Product Change Notice (PCN)

PCN Number: PCN-0450011R-01

Product(s) Affected: PJ-069B-SMT-TR

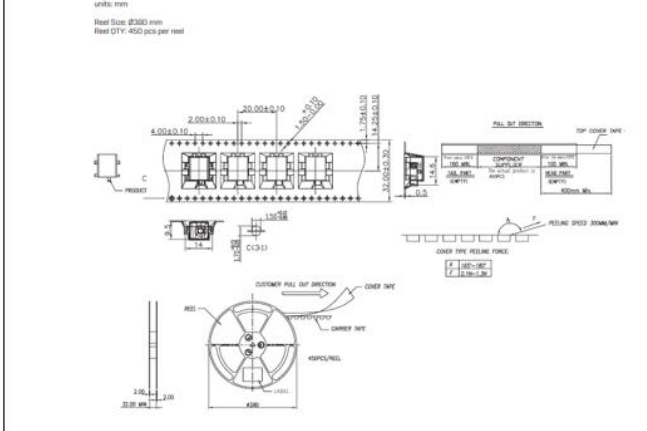
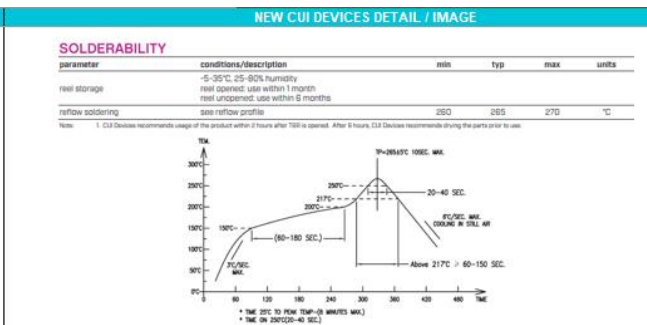
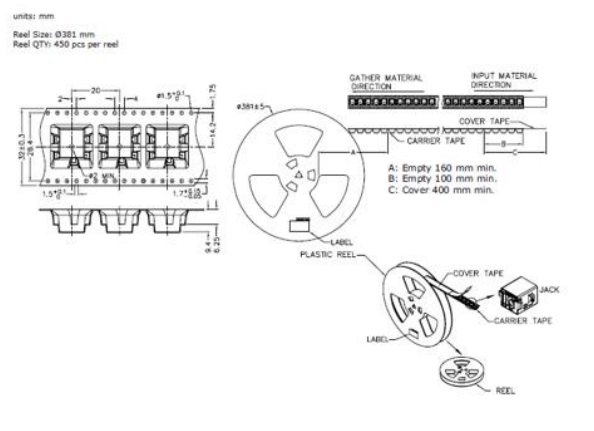
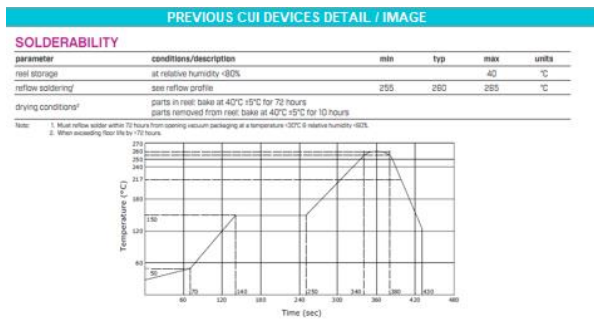
Description of Change: *Materials and packaging update*

MATERIAL	PLATING																																															
center pin	brass	nickel																																															
terminal 1	brass	silver																																															
terminal 2	copper alloy	silver																																															
terminal 3	brass	silver																																															
shield-A	brass	nickel																																															
shield-B	stainless steel																																																
plastic	PA6T or equivalent																																																
DESCRIPTION	MATERIAL	PLATING/COLOR																																															
center pin	copper	nickel																																															
terminal 1	brass	silver																																															
terminal 2	copper alloy	silver																																															
terminal 3	brass	silver

shield-A	brass	nickel																																															
shield-B	stainless steel																																																
housing	PA10T (UL94V-0)	black																																															
 <p>MATING PLUG Jack Insertion Depth: 8.2 mm</p>	 <p>MATING PLUG Jack Insertion Depth: 8.3 mm</p>
